Correction of the range offset error in Stripmap [10 m] and ScanSAR [350 km / 490 km] modes

November 22, 2018

JAXA ALOS-2 Project Team / EORC

Figure: Comparison of the range offset images before and after update.

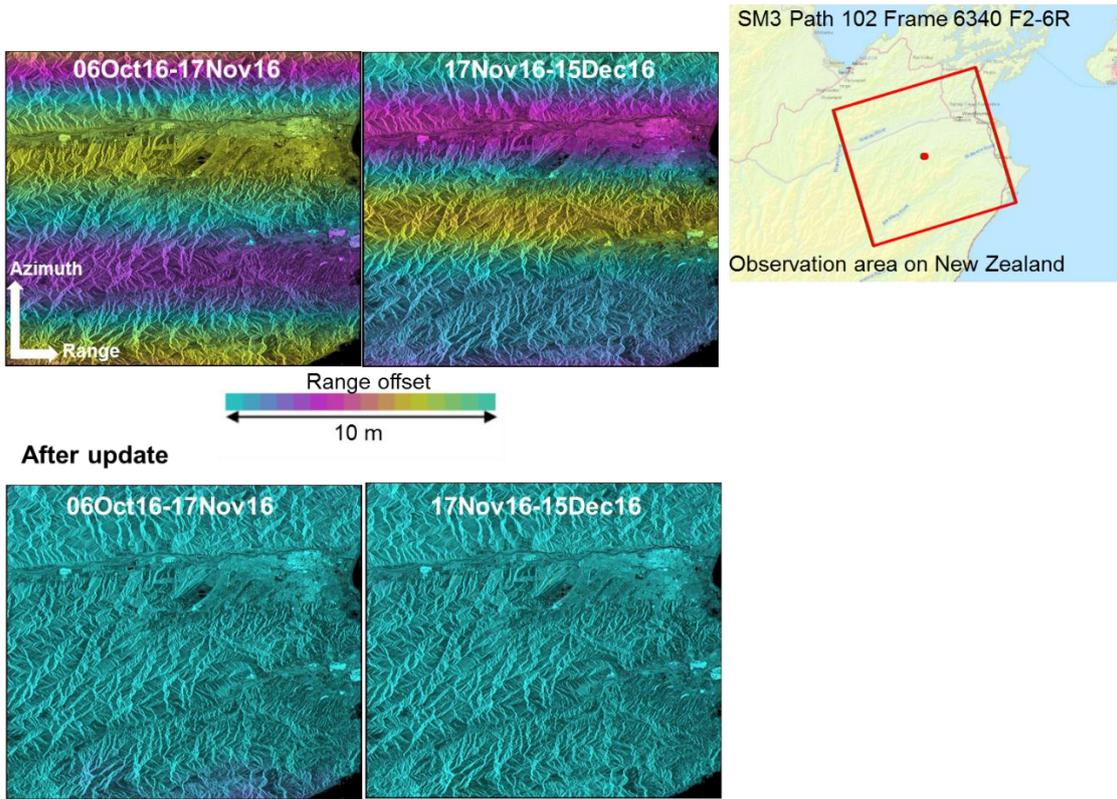
On November 20, 2018 (JST), JAXA updated the software for PALSAR-2 standard products to fix the range offset error which was confirmed in some Stripmap [10 m] scenes (please see *1). We confirmed that the range offset error was removed after the software update. Please see the next page for the comparison results before and after the software update.

When you order a standard product after updating the software on November 20th (JST), range offset error free PALSAR-2 standard product is delivered.
